PLANNING REPORT

Architectural Review Board

Sharpin Residence 26-034MPR

Case Summary

Floodplain (Green box is location of addition)

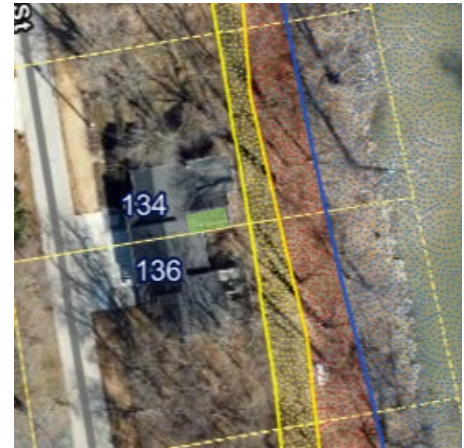
The lot contains some floodplain, but the addition stays within the current footprint of the residence and does not encroach that floodplain.
